YANKEE ATOMIC ELECTRIC COMPANY

December 12, 1989
BYR 89-175

Subject: Additional Information on YAEC-1363, "CASMO-3G Validation"

RESPONSES TO REQUEST FOR ADDITIONAL INFORMATION
CONCERNING YAEC-1363, CASMO-3G VALIDATION
QUESTIONS AND ANSWERS

Table 8.2
DIXY G-factors for a GE High Energy Bundle

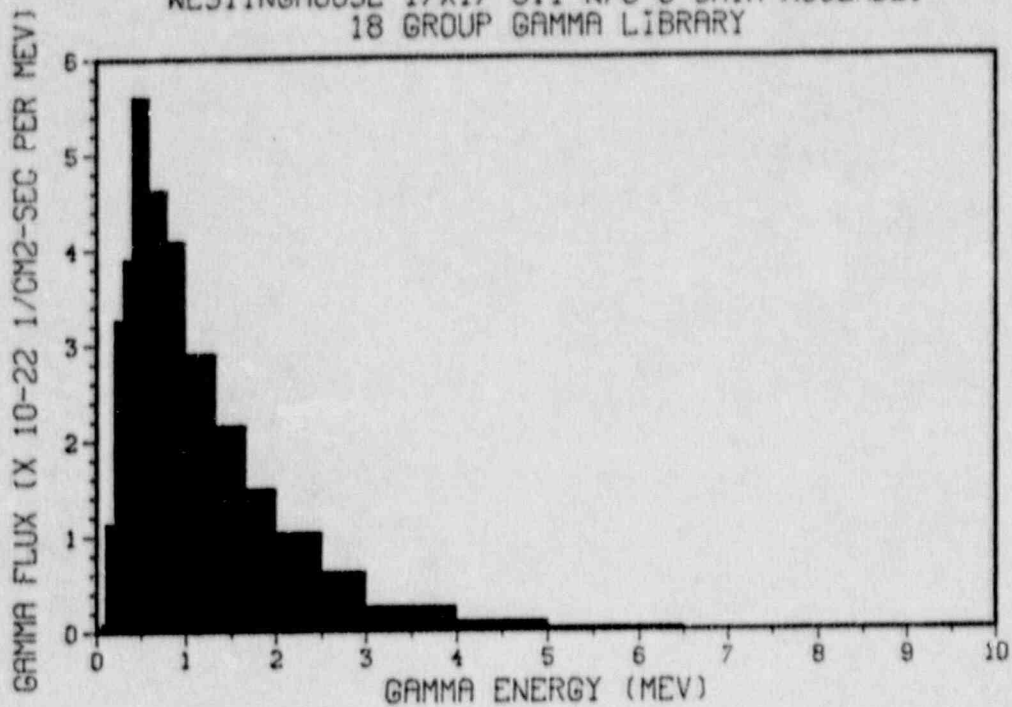
8) Q. *How large are the G-factor material dependent multipliers for typical BWR and PWR assemblies?*

G-factors for a Vermont Yankee 8 x 8 CE BWR high energy bundle at 40% void are presented in Table 8.2. This bundle contains seven fuel rods of three different U-235 enrichments which contain 5 w/o gadolinia burnable absorber. There are also four water rods, and the wide and narrow water gap regions. G-factors are calculated for each of these regions and are presented in Table 8.2 along with the relative absorption rate differences between the DIXY and COXY calculations, with and without use of the G-factors.

Tables 8.1 and 8.2 demonstrate the difficulty that diffusion theory has in modeling strongly heterogeneous lattices without using G-factors. The CASMO-3G / SIMULATE-3P methodology utilizes the COXY calculated intra-assembly detail when calculating the pin-by-pin power distribution in an LWR core. Therefore the application of G-factors is eliminated.

FIGURE 1.1
 GAMMA ENERGY SPECTRUM AT DETECTOR
 WESTINGHOUSE 17X17 3.1 W/O O SHIM ASSEMBLY
 18 GROUP GAMMA LIBRARY

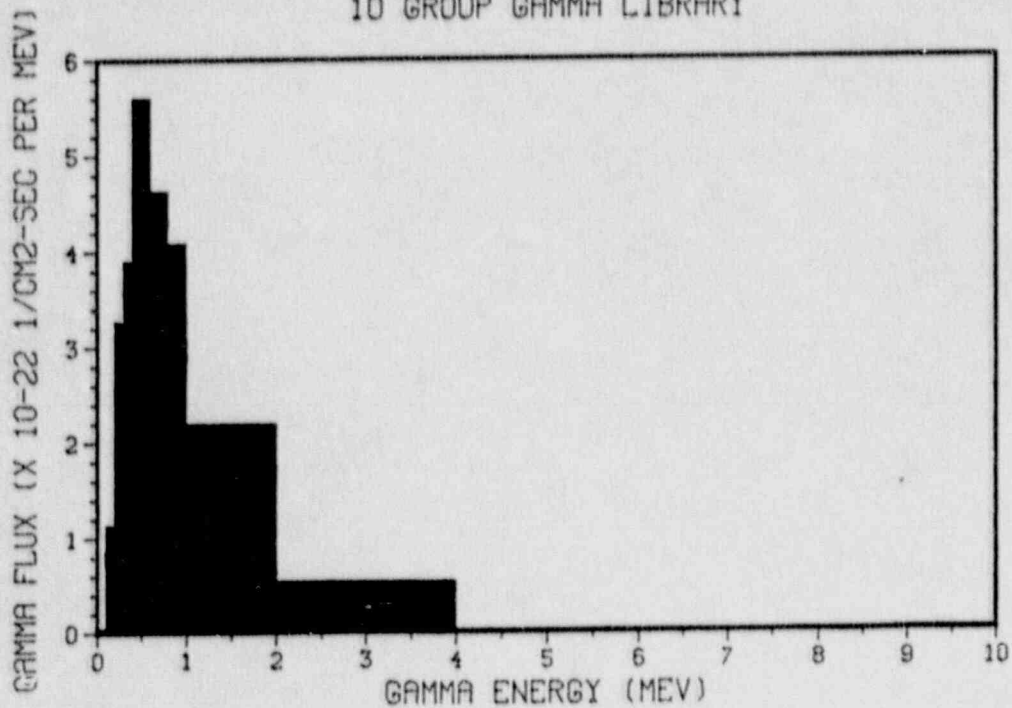
- 1) Q. *What error is introduced in the gamma detector response/bundle power correlation by using the 10 group rather than the 18 group library?*
- A. The energy group structures for the 10 group and 18 group libraries are provided in Table 1.3 of YAEC-1363. The 10 group library maintains essentially the same energy group definition as the 18 group library for the lower energy groups up to 1.0 MeV, with a coarser energy group structure in the high energy range. The gamma energy distribution in a Westinghouse 3.1 w/o unshimmed assembly is provided in Figure 1.1 for both the 18 group and 10 group gamma cross section libraries. Comparison of these energy spectra demonstrates that the loss in clarity at the high energy levels with the 10 group library results in a small effect on the overall gamma flux energy and spatial distribution. The total detector responses were calculated for this problem using the CASMO-3G default gamma detector sensitivity functions for iron, and were 2.030×10^{23} 1/cc-sec and 2.033×10^{23} 1/cc-sec for the 18 group and 10 group libraries, respectively. This represents a detector response difference of 0.15 percent.
